**RE: Fountain Hills Plaza Assisted Living
Grading Plan
Engineer Stamp Date: 12/06/17
Hydrology File: C12D003B8**

Based upon the information provided in your submittal received 12/06/2017, the Grading and Drainage Plan **is not** approved for Building Permit, Site Plan for Subdivision, Site Plan for Building Permit, and Grading Permit. The following comments need to be addressed for approval of the above referenced project:

FOUNTAIN HILLS PLAZA ASSISTED LIVING GRADING PLAN

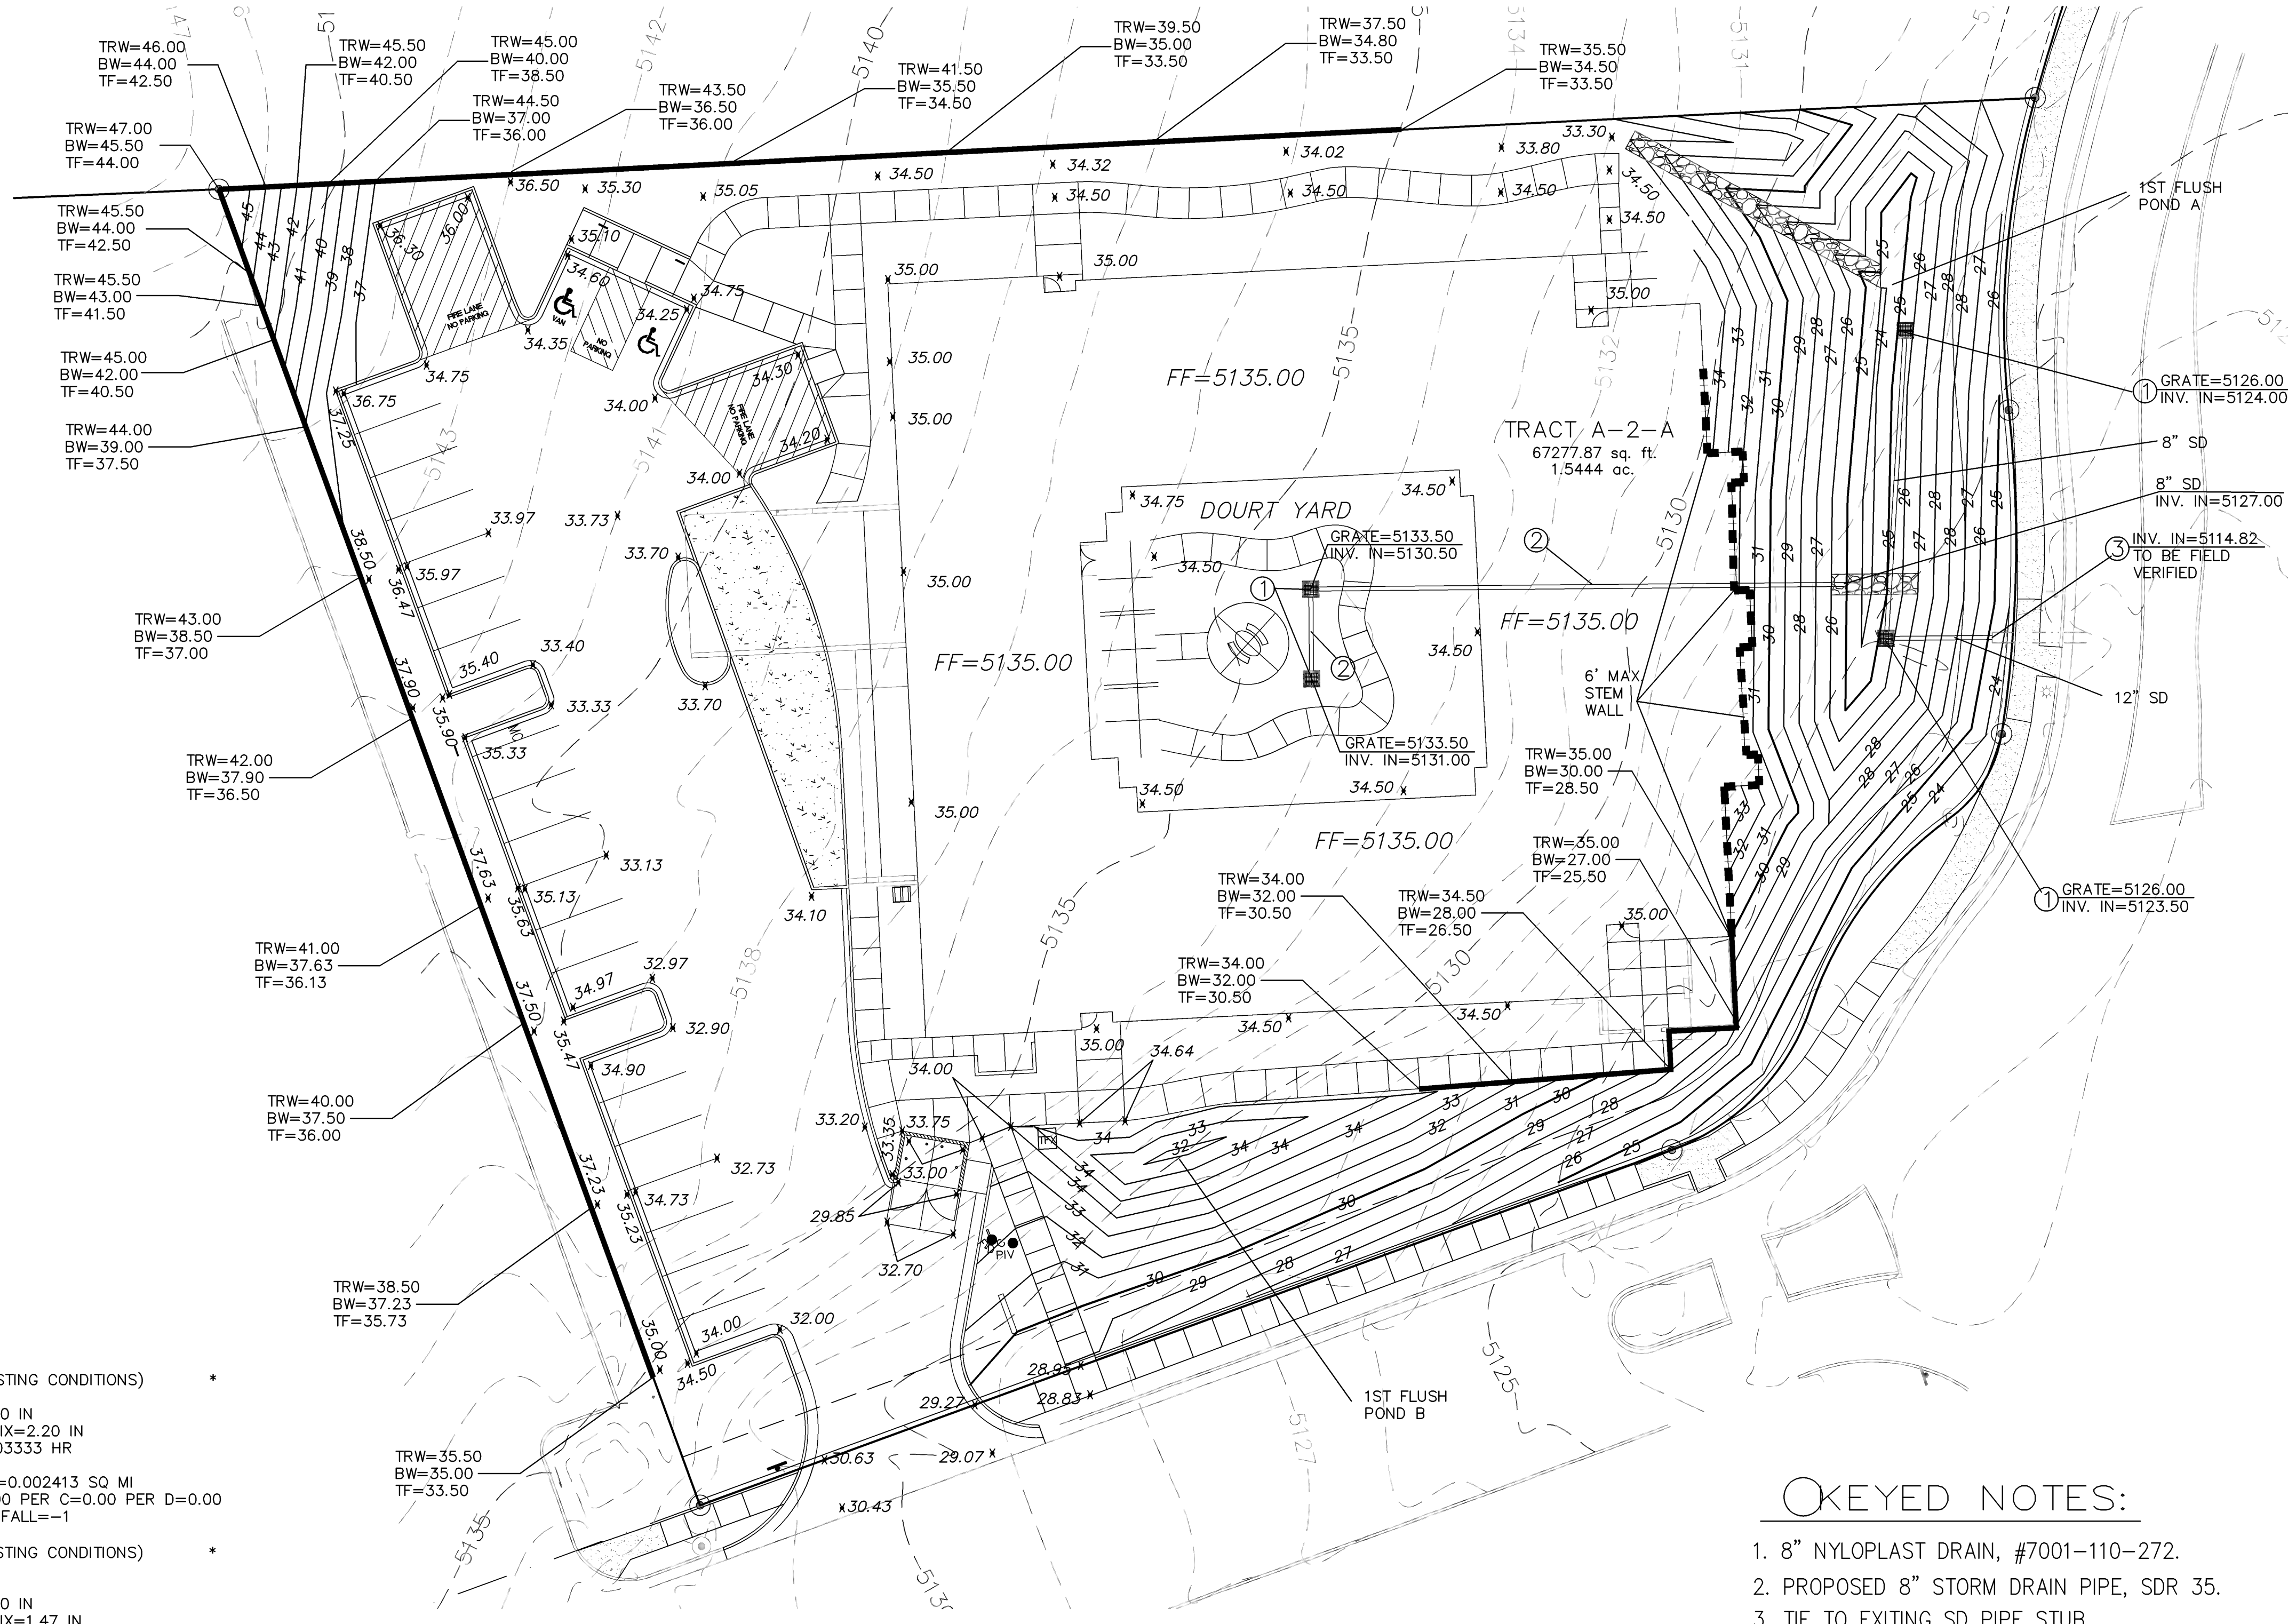
1. Please provide the flood plain effective date to the FIRM information.
2. Please label both adjacent streets.
3. Please show and label all nearby existing storm sewer. See attached as-built plan & profile for the storm sewer.
